# Access Compliance Report

## Public Rights-of-Way

### (Pedestrian Signals)

Intersection ID: N/A	Main Street:	Cross Street: N/A	Location: N/A
ADA ID: 5C7E1B5EB42E	Signal Type: One Push Button-APS	Overall Compliance: No	Severity Score: BTN 1: N/A BTN 2: N/A No BTN: N/A
Codes/Mitigation Info/Possible Solution		Field Measurements/Component Compliance

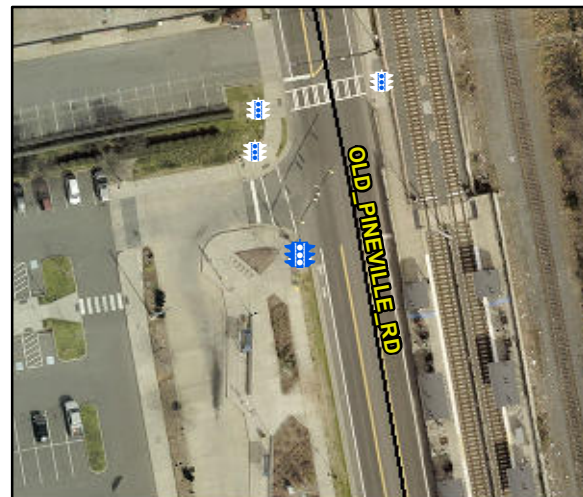
Compliance	Description	Data	Compliance	Description	Data
	Button Count	Button1	N/A	Distant to Additional Button (in)	N/A
	Additional Button Present?	No		Additional Button ID	N/A
N/A	Signal Buttons Required?	N/A	N/A	Additional Ped Posts Required	N/A
	How Many Ped Street Xings?	1		Located In An Island/Median?	No
No	B 1 Sign Present?	N/A	N/A	B 2 Sign Present?	N/A
N/A	B 1 Sign Purpose?	Yes	N/A	B 2 Sign Purpose?	N/A
N/A	B 1 Sign Lettering & Contrast?	N/A	N/A	B 2 Sign Lettering & Contrast?	N/A
N/A	B 1 Parallel To XWalk?	Yes	N/A	B 2 Parallel To XWalk?	N/A
Yes	B 1 PAR to Button?	Yes	N/A	B 2 PAR to Button?	N/A
Yes	B 1 PAR to XWalk?	Yes	N/A	B 2 PAR to XWalk?	N/A
Yes	B 1 Clear Floor Space?	Yes	N/A	B 2 Clear Floor Space?	N/A
N/A	B 1 FWD Approach?	Yes	N/A	B 2 FWD Approach?	N/A
N/A	B 1 FWD Approach Constrained?	No	N/A	B 2 FWD Approach Constrained?	N/A
No	B 1 FWD Approach Reach (in)	15.0	N/A	B 2 FWD Approach Reach (in)	N/A

N/A	B 1 FWD Approach Width (in)	N/A	N/A	B 2 FWD Approach Width (in)	N/A
N/A	B 1 FWD Approach Obstruction?	Yes	N/A	B 2 FWD Approach Obstruction?	N/A
N/A	B 1 FWD Approach Obstruction Dist (in)	9.0	N/A	B 2 FWD Approach ObstructionDist (in)	N/A
N/A	B 1 PARA Approach?	No	N/A	B 2 PARA Approach?	N/A
N/A	B 1 PARA Approach Constrained?	N/A	N/A	B 2 PARA Approach Constrained?	N/A
N/A	B 1 PARA Approach Reach (in)	N/A	N/A	B 2 PARA Approach Reach (in)	N/A
N/A	B 1 PARA Approach Width (in)	N/A	N/A	B 2 PARA Approach Width (in)	N/A
N/A	B 1 PARA Approach Obstruction?	N/A	N/A	B 2 PARA Approach Obstruction?	N/A
N/A	B 1 PARA Approach Obstruction Dist (in)	N/A	N/A	B 2 PARA Approach ObstructionDist (in)	N/A
No	B 1 Clear Floor Space Slope (%)	11.0	N/A	B 2 Clear Floor Space Slope (%)	N/A
No	B 1 Clear Floor Space XSlope (%)	4.4	N/A	B 2 Clear Floor Space XSlope (%)	N/A
N/A	B 1 PAR Slope (%)	3.5	N/A	B 2 PAR Slope (%)	N/A
Yes	B 1 Height (in)	38.0	N/A	B 2 Height (in)	N/A

Yes	B 1 Clear Xing Direction?	ClearlyMarked	N/A	B 2 Clear Xing Direction?	N/A
	B 1 Crossing Direction	To NW		B 2 Crossing Direction	N/A
Yes	B 1 DistanceTo XWalk (in)	0.0	N/A	B 2 DistanceTo XWalk (in)	N/A
No	B 1 DistanceTo Curb (in)	108.0	N/A	B 2 DistanceTo Curb (in)	N/A
Yes	B 1 Diameter (in)	2.0	N/A	B 2 Diameter (in)	N/A

Possible Solutions: Replace Signal Push Button With APS Button on New Post.
